To: T10 Technical Committee
From: Bob Sheffield(robert.l.sheffield@intel.com)
Date: 18 August 2006
Subject: 06-378r0: SAT - Miscellaneous changes

Figure 4 — Example of a SATL between a SCSI application client and an ATA or ATAPI device

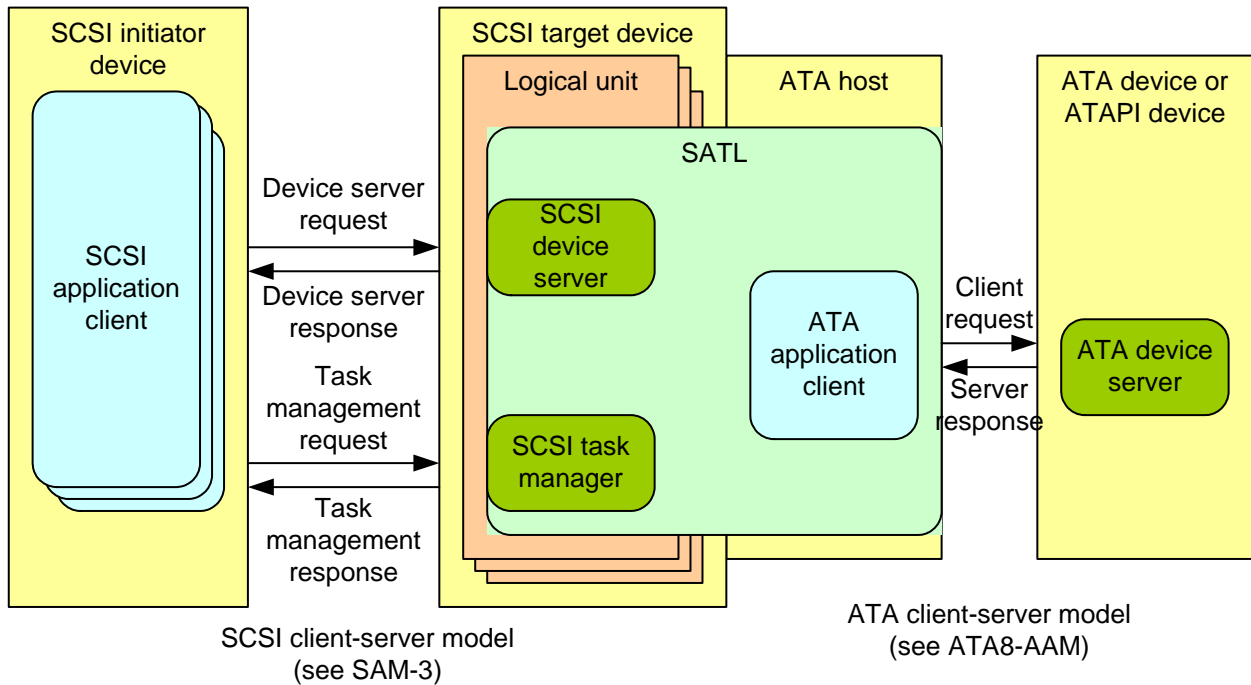
Editor's Note 1: Replaced figure-4. This is more consistent with figures in SAM-3 and ATA8-AAM. Credit goes to Rob Elliott for creating this diagram.
